Environmental Review Team  
Report

Walnut Farms Drive  
Farmington, Connecticut

April 1984

ENVIRONMENTAL REVIEW TEAM REPORT  
ON  
WALNUT FARMS CLUSTER DEVELOPMENT  
FARMINGTON, CONNECTICUT

# Preliminary Site Plan

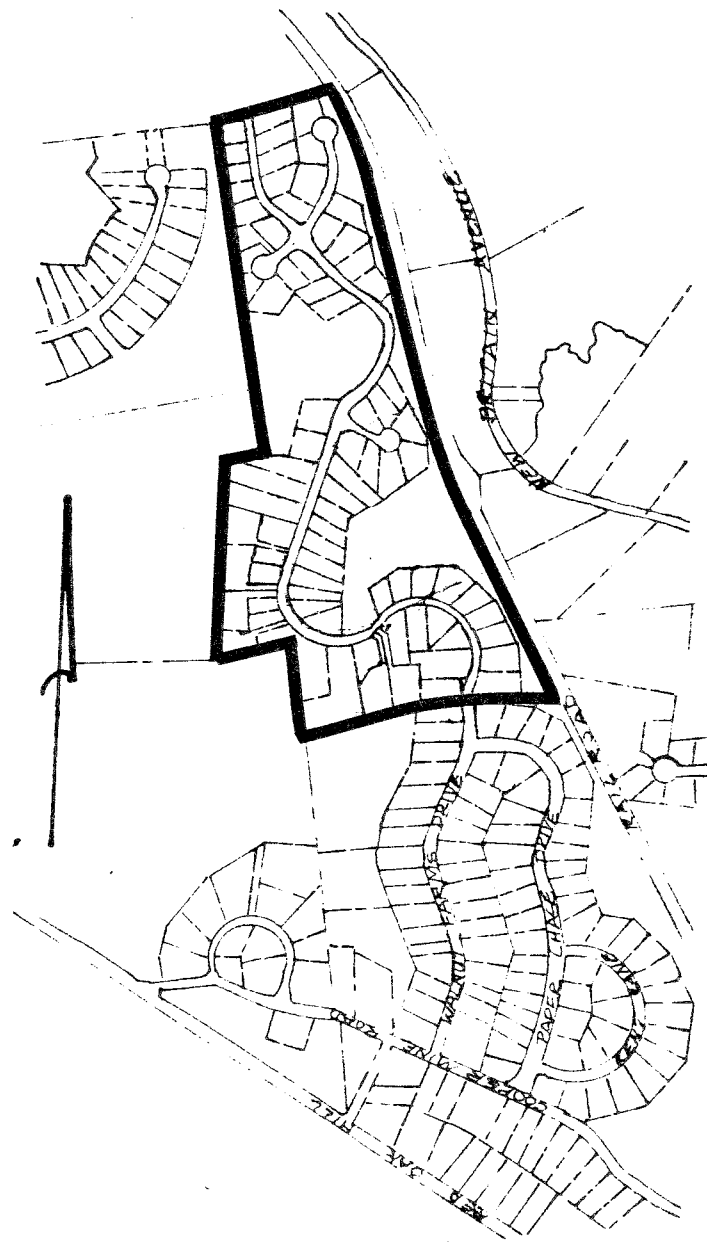
The MgC soils are droughty soils and establishing vegetation on steep slopes must be carefully done, using materials which are drought-tolerant. A long, steep slope is planned where the main road will be cutting through approximately stations 28 to 33. If access were made available from New Britain Avenue, this area could

possibly be avoided and left in its natural condition. During the field review, it was mentioned that access could be obtained off New Britain Avenue. The southern part of the development could stop at a cul-de-sac at lot 27. The access road would then turn north from lot 28. However, during the review it was also mentioned that for fire access the development road should continue through this steep sloping area along with construction of the access road from New Britain Avenue. If the main road is constructed through this steep sloping area, vegetation should be established as soon as final grading of the slope is completed. The slope should be limed, fertilized, seeded, mulched and anchored with erosion control netting. A hydroseeder could be used along with a mulching machine. It is extremely important that the correct plant materials and seeding dates be used. An excellent seed mixture would be (1½ lbs/1,000 square feet) Kentucky 31 Tall Fescue and Creeping Red Fescue. Seeding dates for this mixture are April 1 - June 15 or August 15 - September 30. It would be best to final grade this area as close to these seeding dates as possible. After grass vegetation is established, the following spring, white pine seedlings could be planted to further assist in stabilizing the slope.

The proposal could be developed from lots 1 through 9, 71-78 as part of Phase I.

1. During construction of roadway embankments, utilize calcium chloride and/or water to minimize dust conditions.
2. Trucks transporting materials to the site, away from the site or on site should be covered during transit to minimize dust conditions.
3. Utilize on-site material from cut sections for all fill areas.
4. Investigate the use of a toe-of-slope or side slope retaining structure (e.g., bin wall, gravity wall, reinforced earth wall) to minimize the cut section in the slope left of Walnut Farms Drive Station 31+0.

The current plan will create a dead-end street more than 4500 feet long. Although this situation is intended to be "temporary," it is not desirable for cul-de-sac streets to be over 1000 feet long. In some cases, exceptions to this standard must be made because of unusual topography or other circumstances. The Town should consider the implications of such a long dead-end street to public safety and the provision of school transportation.

The possibility of terminating the extension of Walnut Farms Drive at approximately Station 29 and of linking the remaining portion of the development directly to New Britain Avenue across property owned by the Town of Farmington and the State of Connecticut was discussed during the field review. The extension of Walnut Farms Drive would then become a permanent dead-end street approximately 3000 feet long. For the reasons cited previously, this is not advisable.

# Drainage Areas

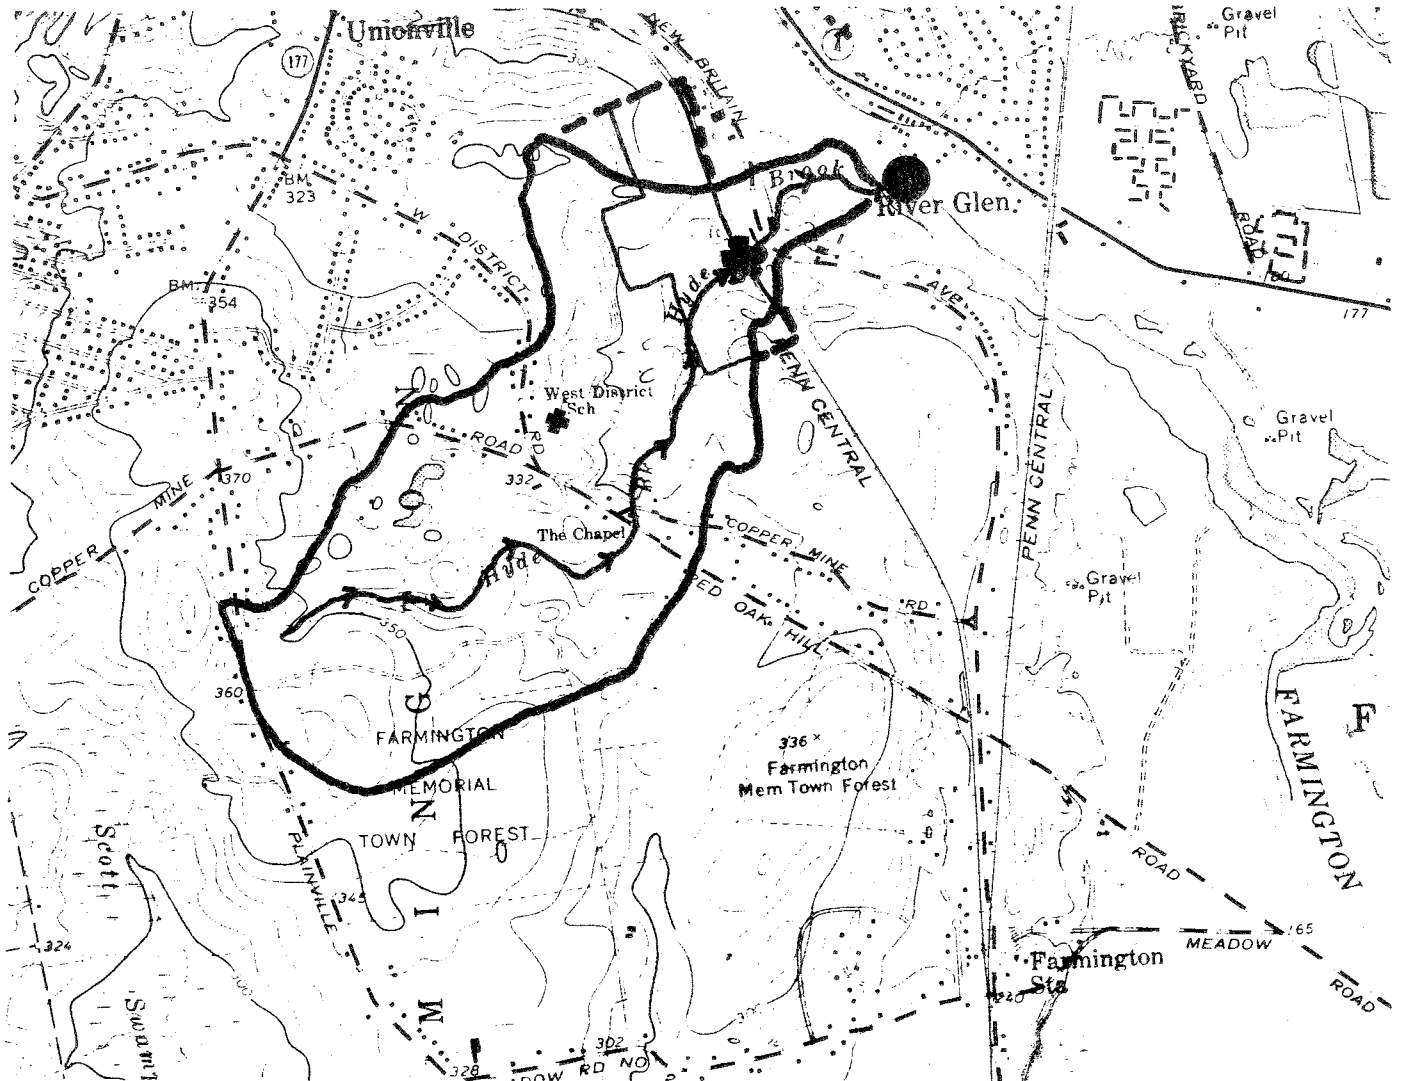
side of the railroad bed. As a result, surface water flows from these areas appear to be directed into the watershed of Hyde Brook. The size of the Hyde Brook watershed, the outlet for the pond, including the northern and southern portions of the property lying outside of it is approximately 475 acres. A  $\pm 1$  acre pond, which is an impoundment of Hyde Brook, is located in the east central portion of the site. According to the site plans, stormwater will be artificially collected and dispersed into this area. The outlet for the pond is controlled by a weir. From the outlet point, Hyde Brook flows eastward, ultimately discharging into the Farmington River. Hyde Brook also passes through a culvert under New Britain Avenue.

Development of the 65-acre parcel as planned can be expected to increase the amount of runoff from the site for a given rainfall amount and to thereby increase peak flows into the proposed detention area (pond) in the eastern limits of the site and ultimately to Hyde Brook. These increases would be caused by removal of vegetation, compaction of soil during the construction phase, and creation of impervious surfaces such as roofs, driveways, and roads.

Prior to approval of the proposed development, it is recommended that the applicant be required to submit detailed hydrological information on pre- and post-development runoff volumes and peak flows from the property. Estimates should be provided for a 10, 25, 50, and 100 year design storm. In addition, detailed design specifications for the proposed detention pond(s) should be submitted for review along with the hydrological information. The detention pond may also serve as a sediment retention function. If so, measures should be taken to remove the sediment periodically, since a build up of the the material can diminish the runoff storage capacity of the pond. Also, the project engineer should take a close look at the culverts passing under the railroad bed and New Britain Avenue to determine if they can handle post-development flows from the site.
